Accessibility Survey

City of Downey Fairford Avenue - Florance Avenue to Cecilia Street

Date of Inspection
2/9/2017

Disability Access Consultants

Change In Level South of Buell Street @ 33.932264707156, -118.094815760851

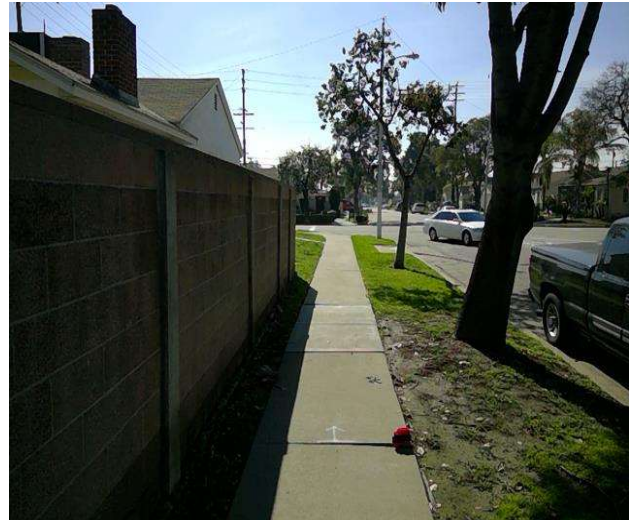
There is a change in elevation greater than recommended value.

On-Site Finding 0.87 inches

Ensure that the change in elevation is within the recommended value.

Recommendation Up to 0.25 inches
